PlanGrid Task Report - Sep 25, 2024

L05649_Blairs Ferry Rd FSU (IA)

3241 Blairs Ferry Road Northeast, Cedar Rapids, Iowa

#109 [UNIT 999][NEW] (MISC) AC-3 Constant Fan ON

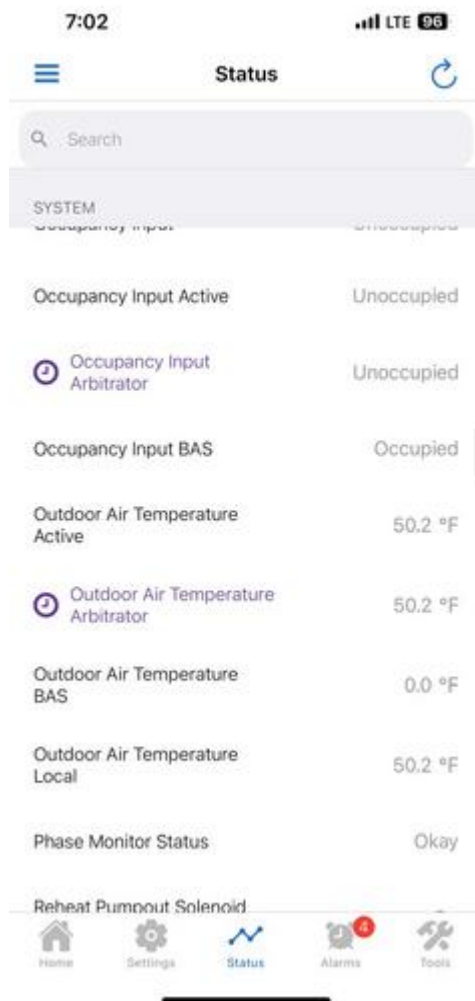
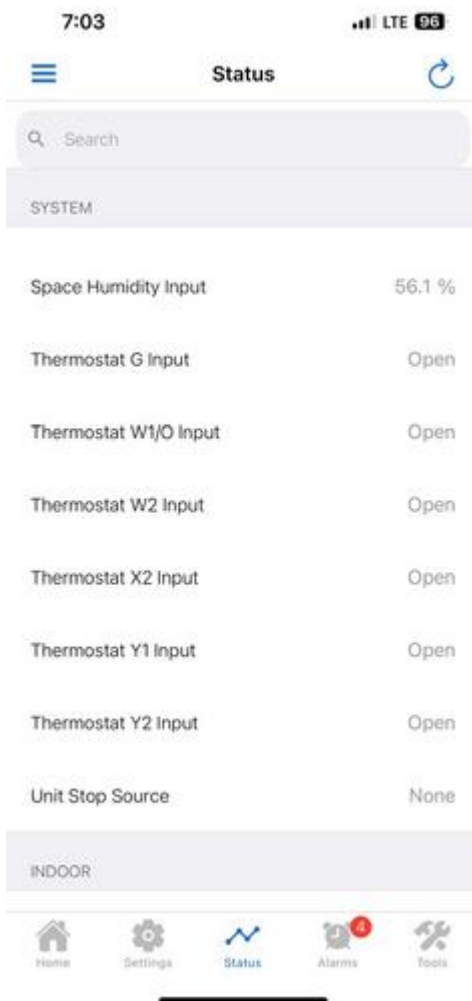
AC-3 is running fan only constantly, despite occupancy input / thermostat signal. When in unoccupied, unit runs fan only with no call for fan, no demand, and no voltage at G. All settings parameters appear correct. Recommend TRANE is contacted. Service needed.

#86 [UNIT 516][NEW] Condensate Piping Pitch

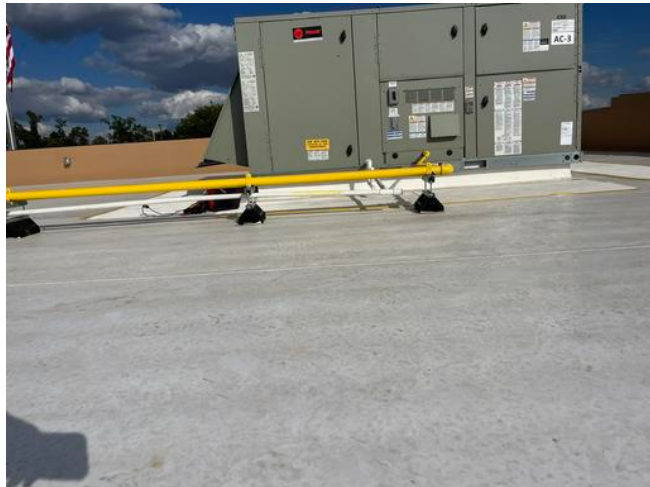
Equipment condensate piping pitch is not sloped correctly in several instances. Piping also lacks support in some spots, usually coinciding with incorrect pitch.

#53 [DUCT 507] [NEW] Ductwork is not fully insulated. Not all seams taped.

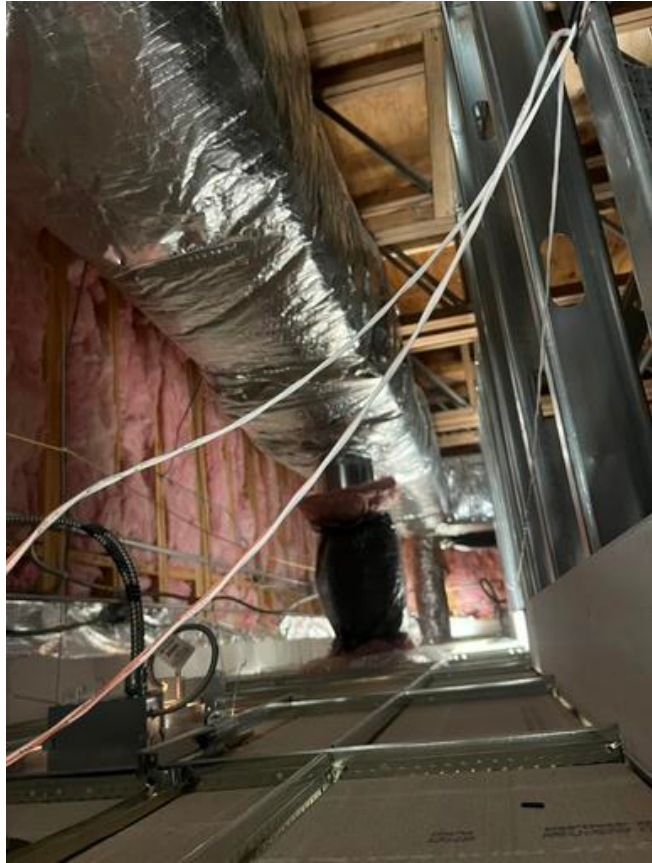
Ductwork not fully insulated. Some areas are missing insulation, or ductwork is poorly insulated with exposed areas and seams not taped/secured. Present on all systems.

#51 [CNTL 003][NEW] CRITICAL - Wiring Specifications

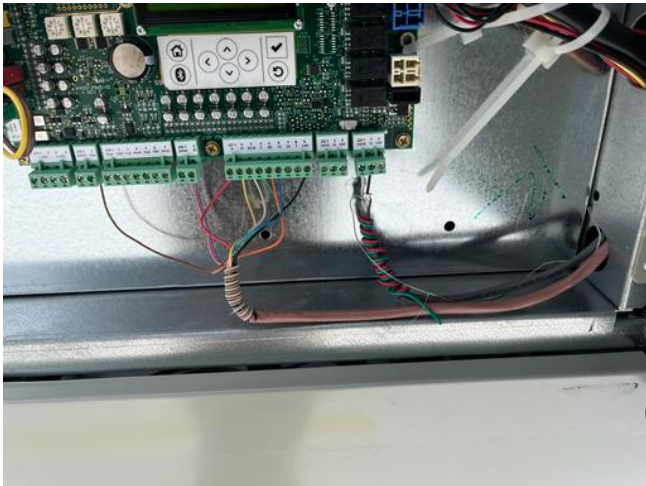
Humidity Sensor cable does not meet spec and is not Connect Air. Readings appear accurate at each sensor: SEEK APPROVAL.

#50 [CNTL 999][NEW] AC-3/4 Temp Sensor Wiring

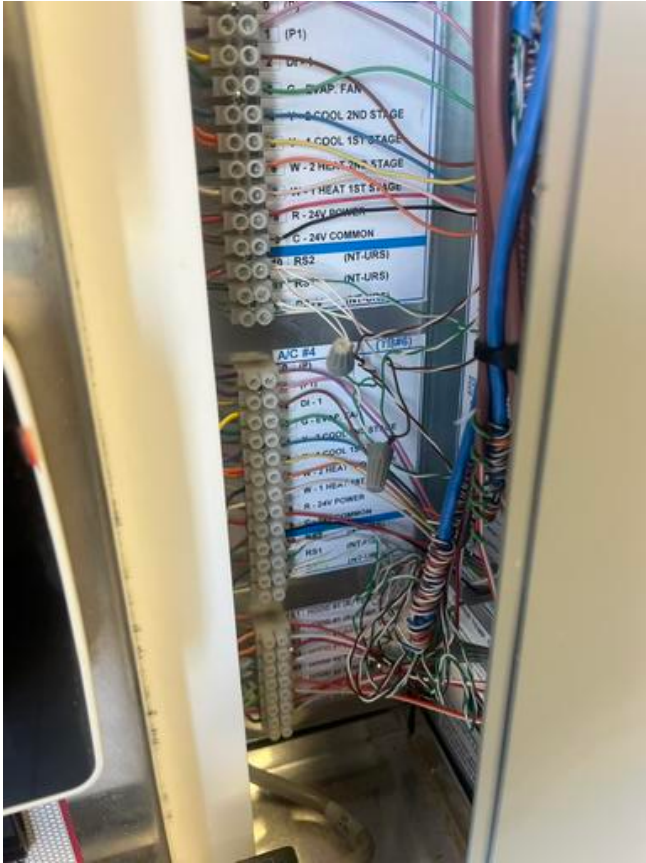
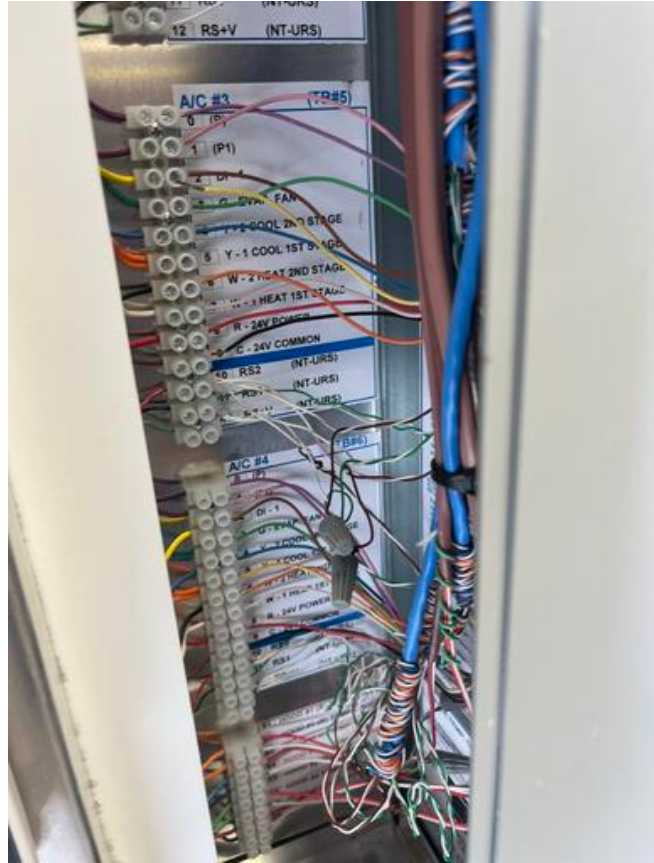
AC-3 and AC-4 to have averaging sensors. Sensors installed, and operating properly/accurately. However, wire was not routed from sensor to sensor, and instead from each sensor back to SEC panel, where connection was made. Operating correctly: SEEK APPROVAL

#46 [EXHA 499][NEW] CRITICAL (MISC) Grease Duct Deviates From Plans

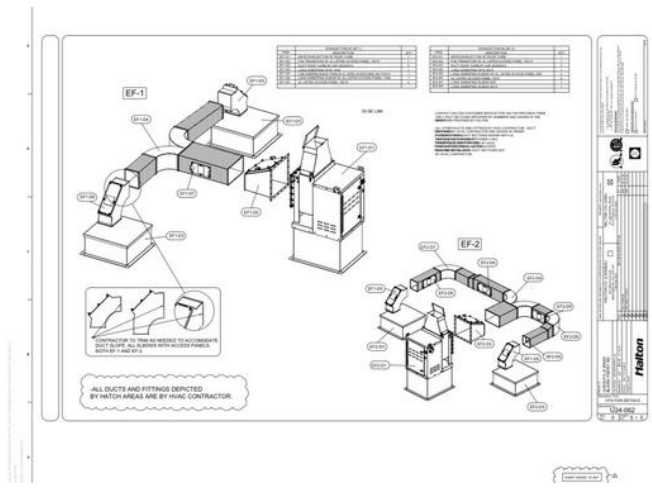
Grease duct deviates from plans and is missing sections that were to be field fabricated. They have been omitted. EF-1 position limited by framing. Exhaust hoods performing at design; SEEK APPROVAL

#45 [EXHA 001][NEW] CRITICAL- Grease Duct Access Doors

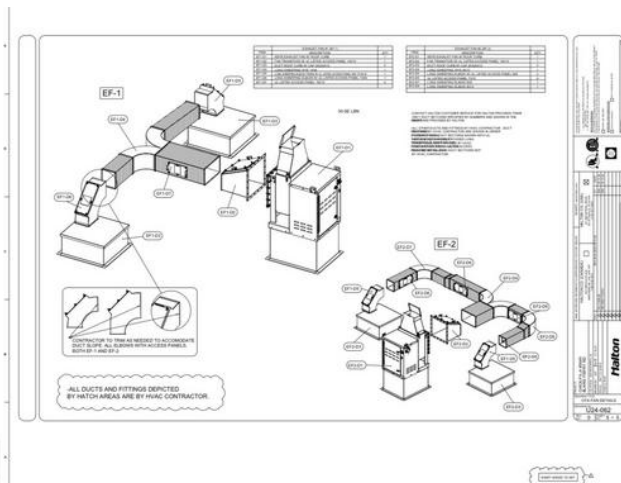
Access door on EF-2 is not installed.

#43 [UNIT 999] [NEW] (MISC) AC-3 Alarmed / Missing Sensors

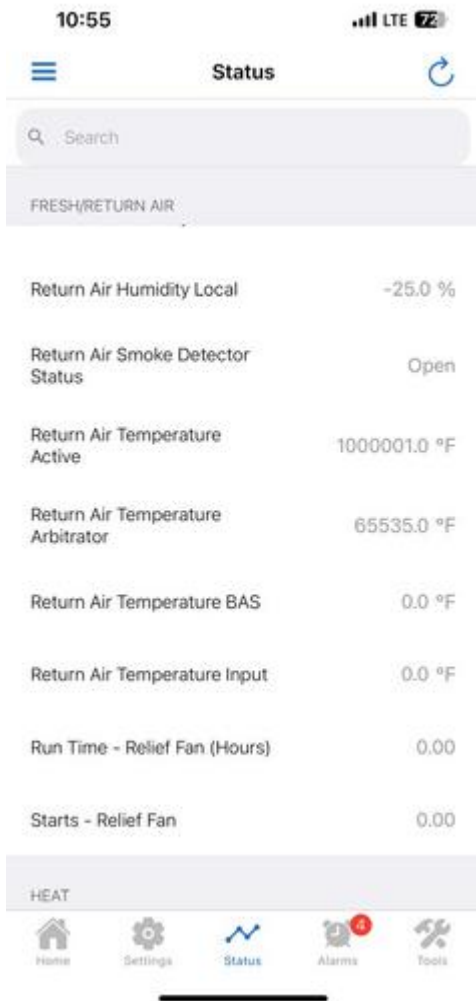
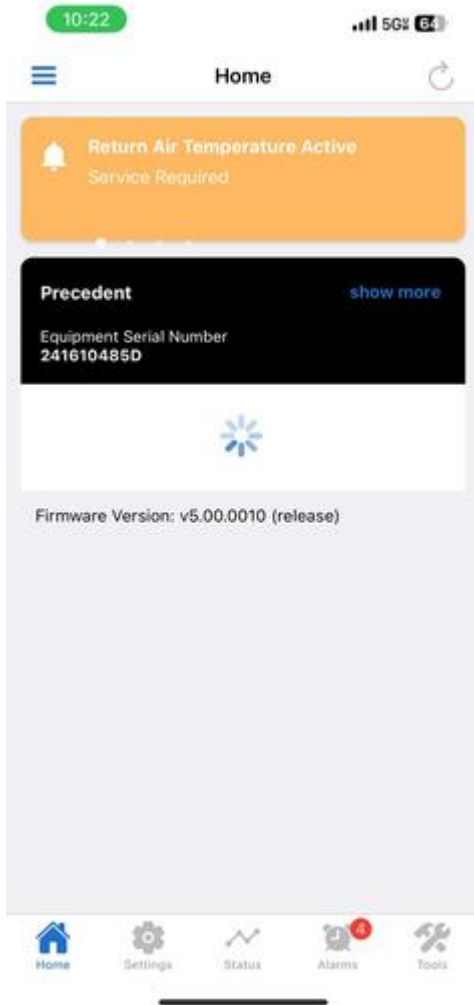
AC-3 is alarmed for Return air Temperature/ Humidity. Return sensors are not installed on this unit and unit is displaying wild readings. Trane was notified, recommend they are contacted again as to absence of sensors and how this impacts operation.

#42 [DUCT 003][NEW] CRITICAL - Canvas Connections

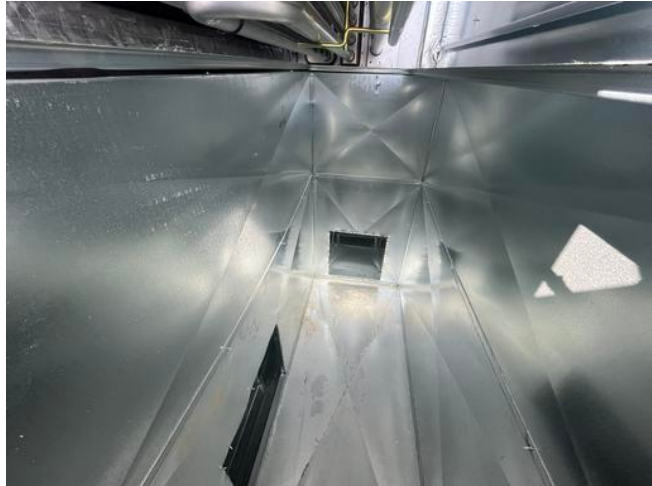
Equipment does not have duct canvas connectors installed at supply or return duct connections. SEEK APPROVAL.

#41 [DUCT 002][NEW] CRITICAL - Turning Vanes in Return Duct

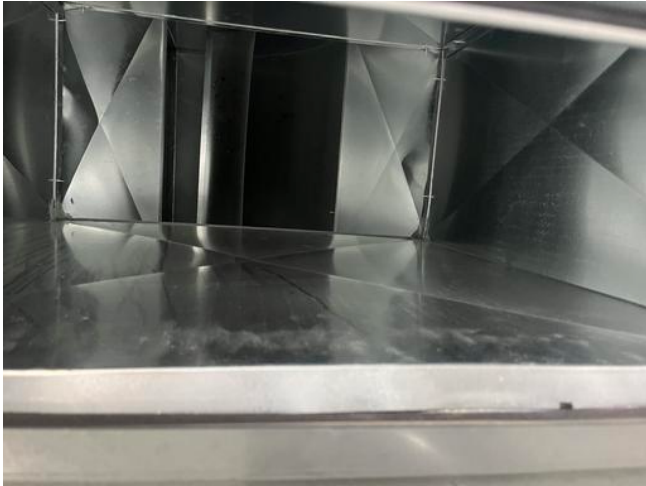
Turning Vanes are present in the return duct on some ACs and need to be removed per specification. MC cannot access vanes to remove: SEEK APPROVAL.

#40 [DUCT 004] [NEW] CRITICAL - Duct Drop Transitions

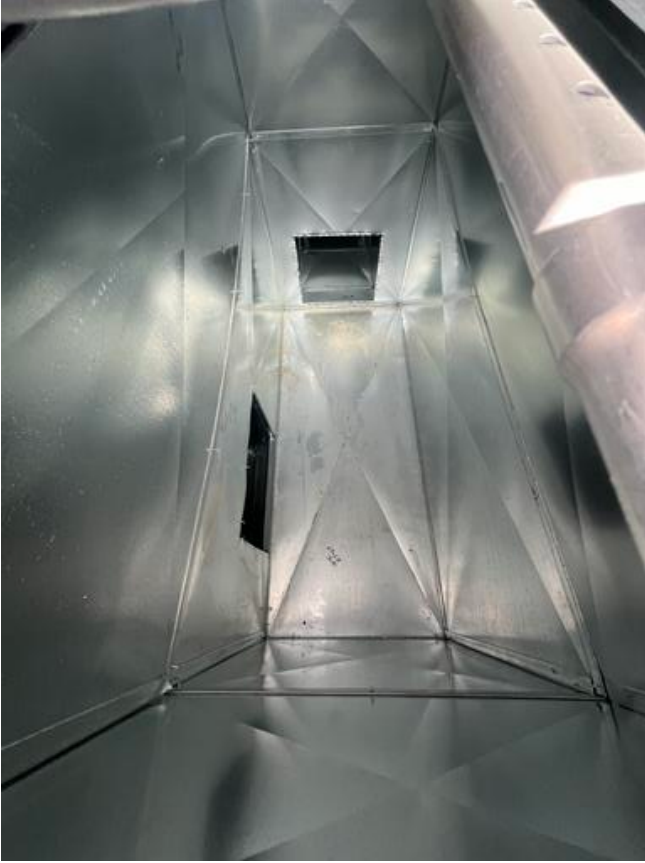
AC duct drops do not match specification. Single turning vane installed in drops. Drops must meet radius specification or have single thickness turning vanes installed as specified in plans. Units performing at design: SEEK APPROVAL.
